## ADDENDUM NO. 6

Reference: Holland Centennial Commons  
Dixie State College – St. George, Utah  
DFCM Project No. 06297640

## ADDENDUM NO. 7

## Addendum 007

**Sheet L104 WHITEHEAD SITE IRRIGATION PLAN / PLANTING PLAN**

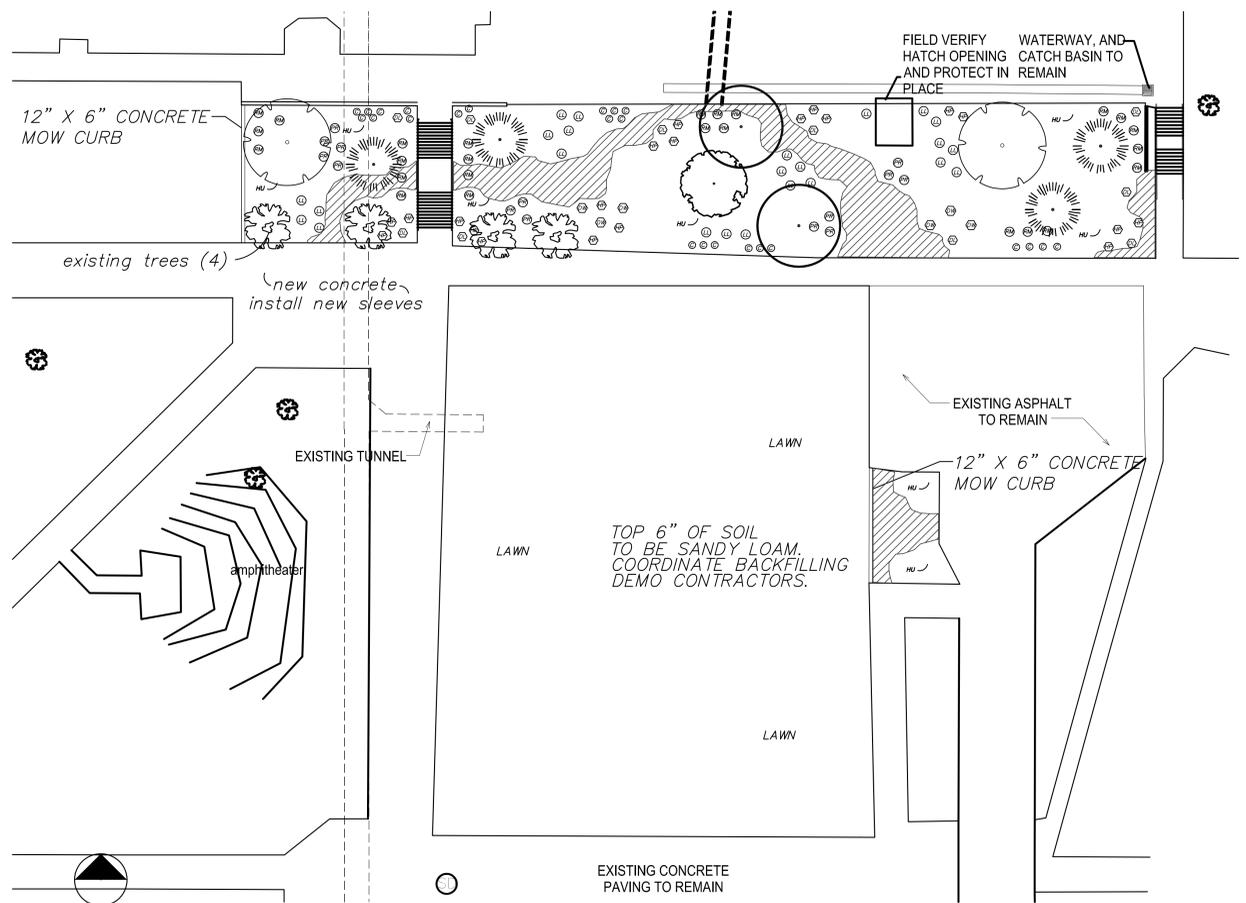
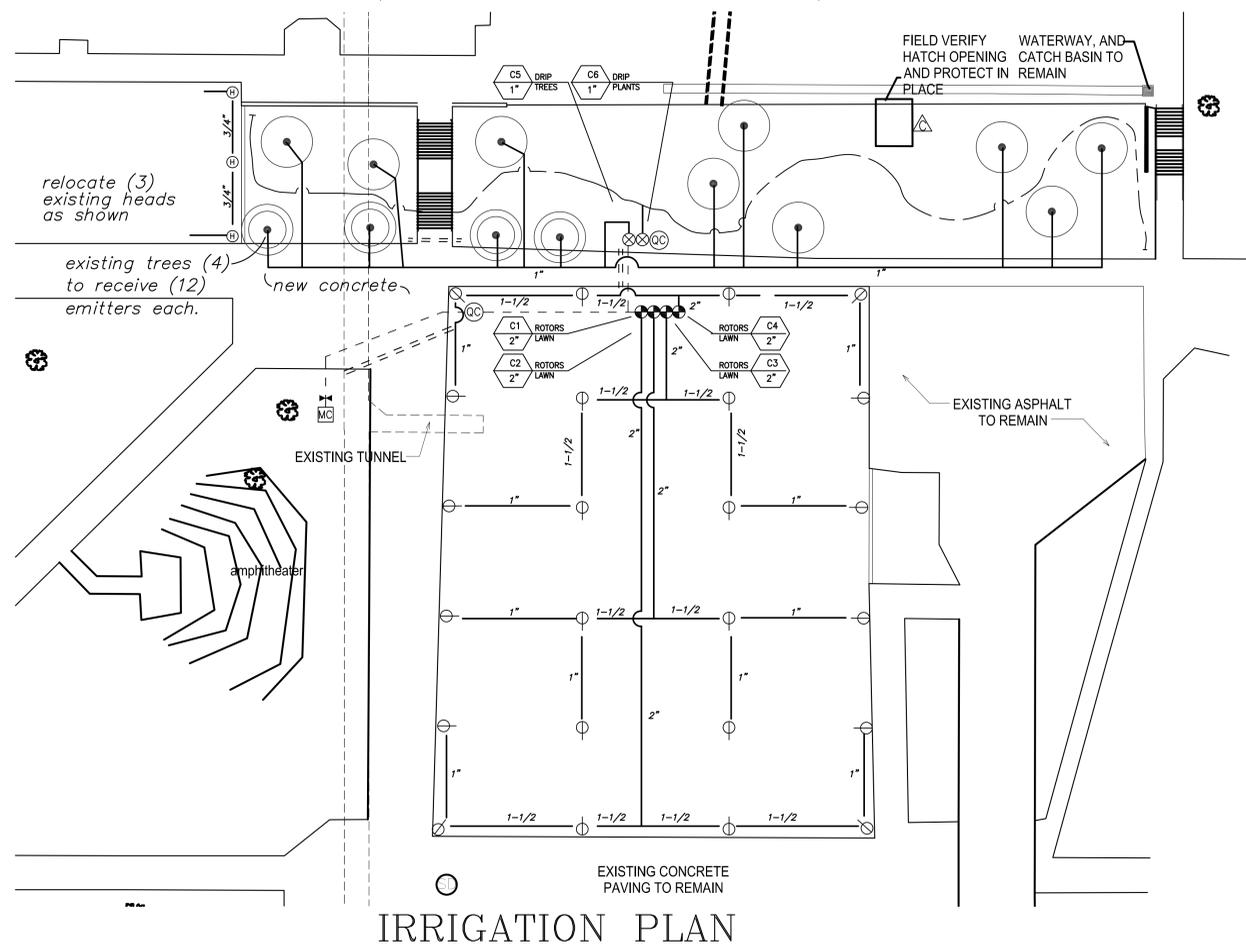
1. Add sheet to set showing landscape and irrigation of Whitehead bldg. demo site.

ORIGINAL SHEET NO:  
MH101

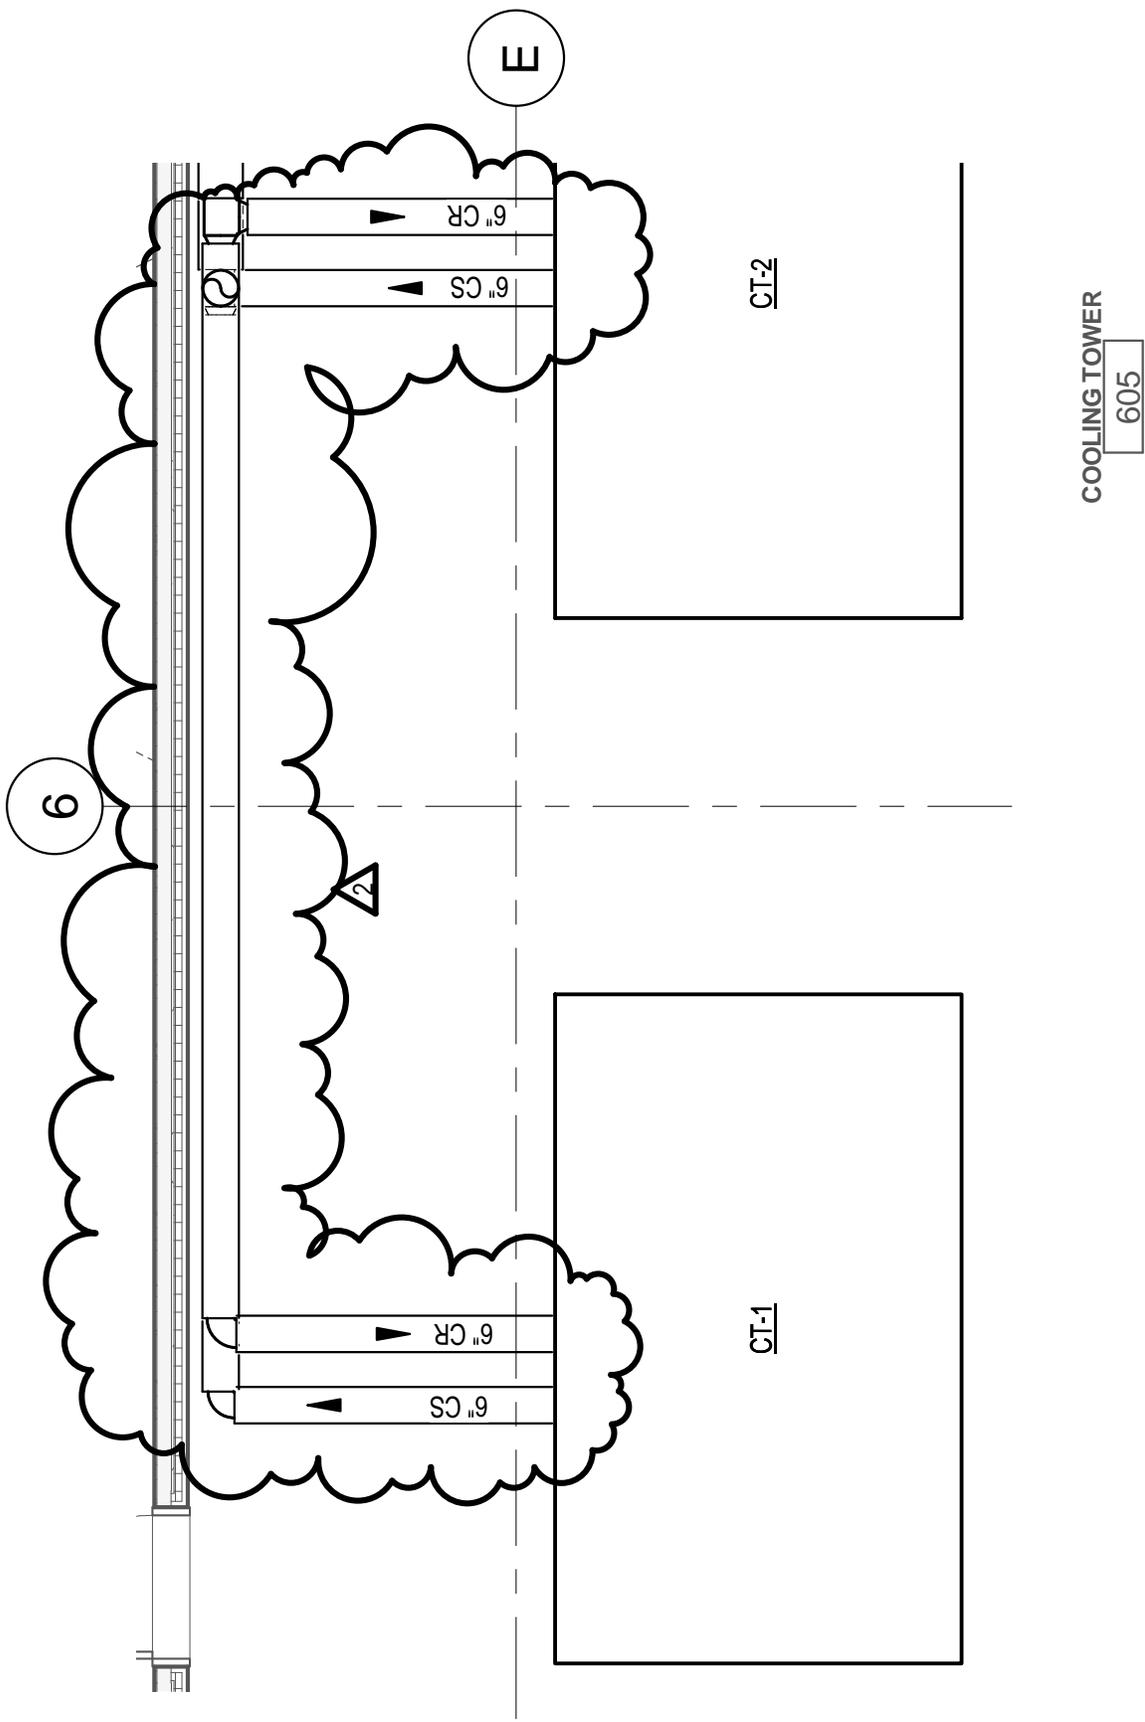
2.4	Add	MH101	Add CO2 sensors to room 162. See ADD 2.01.
2.5	Clarify	MH402	Clarify pipe size connection to cooling towers. See ADD 2.02.
2.6	Clarify	MH202	Clarify heating water pipe size. See ADD 2.03.
